### Appendix M

### **Responses to Public Comments**

This appendix contains the responses to stakeholder and public comments received during the development and public hearing process of the *Total Maximum Daily Loads* for *Toxic Pollutants in Sediment at San Diego Bay Shorelines – Mouths of Paleta Creek, Chollas Creek, and Switzer Creek.*

Appendix M: Toxic Pollutants in Sediment TMDLs Mouths of Paleta, Chollas, and Switzer Creeks – Response to Public Comments

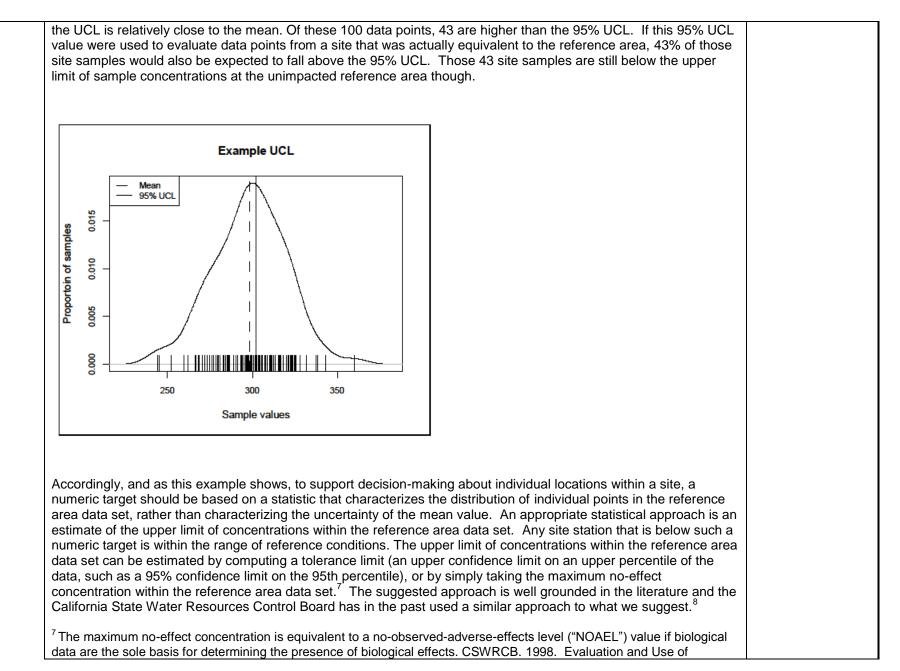
NT-19. No attempt has been made to incorporate TOC normalization into the numeric target analysis			
	<b>Comment</b> : It is unclear why these organic contaminants for which it is widely known are regulated by the presence of organic matter in the sediment, and at Creek mouth locations where the TOC levels range as high as 6%, there is no attempt to incorporate TOC normalization into the analysis. It is unclear that the so called "unimpacted" sites used to develop the target levels are at all representative of the creek mouth areas which are distinctive in the range and variability of their sediment properties for TOC and grain size.	U.S. Navy	
	<b>Response</b> : During the evaluation and development of the sediment chemistry indices for the Aquatic Life SQO MLOE Approach, Southern California Coastal Water Research Project examined the effect of TOC normalization on the predictive ability of sediment quality guidelines. In a comparison of national and regional sediment quality guidelines for classifying sediment toxicity in California, Bay et al. (2012) reported that TOC normalization of organics data did not result in any improvement in correlation or classification accuracy. The San Diego Water Board used the data as provided in the technical reports to make determinations of conditions at the TMDL sites. The data was not modified in any way, including normalizing for TOC.

hig in li rely	<b>mment</b> : A comparison of these targets to low level screening SQGs and background levels, in Table 4-2, is hly misleading. Please present evidence that these levels are consistent with the actual risk at the site, and are ine with other TMDL actions and cleanup actions in the bay. At the stage of implementation, the work should be ying on well-developed, site-specific risk assessment data, not bay wide statistical descriptions and ultranservative national screening levels.	U.S. Navy
Re: diff rep	<b>sponse</b> : When the San Diego Water Board began working on this numeric target selection in 2005-06, seven erent assessment reports were considered to see what contaminants of concern had been indicated in the ports for Chollas and Paleta Creek mouths. The TMDL Phase I and II reports were part of that review, which luded the TIE report.	
Mo Sar the effe nur sea For	th regard to numeric target selection, approaches from other contaminated sediment TMDLs were considered. In the ER-L was used for aquatic life-based TMDLs, the ultra-conservative national screening level. The in Diego Water Board wanted to use a value other than ERLs that was either more locally represented or where a data analysis showed more of a relationship to the triad of results rather than just a percentile cut-off of available ects data nationwide. As a result, the San Diego Water Board began searching for a new way to develop a meric target other than ER-Ls or approaches used to determine human health risk assessment values. The arch for an appropriate statistical analysis was challenging considering the paucity of site-specific data. rtunately, there was an abundance of bay-wide data from the very good datasets that were available for use in the alysis that was performed.

target represents the 95% UCL of the mean of the current "unimpacted" (Category 1 &2) data set.	
Prediction limits are similar to confidence limits, except that they indicate the expected range of the mean in any future surveys of a chosen sample size (n). One option explored was to determine the numeric target for each TMDL site separately in San Diego Bay. In this case, the option considered was to set the analysis to sample a versional number of sites in the future (2 or 3) and run the 95% UCL and prediction limit analysis on the Category 1 & stations from that site only.	
The San Diego Water Board used the raw data as provided in the technical reports to make determinations of conditions at the TMDL sites. The data was not modified in any way, including for grain size or TOC. Bay et al. (2012) found that no significant correlation with TOC and biological effects was observed and it was determined to TOC normalization did not improve the analysis. See response provided in NT-19.	nat
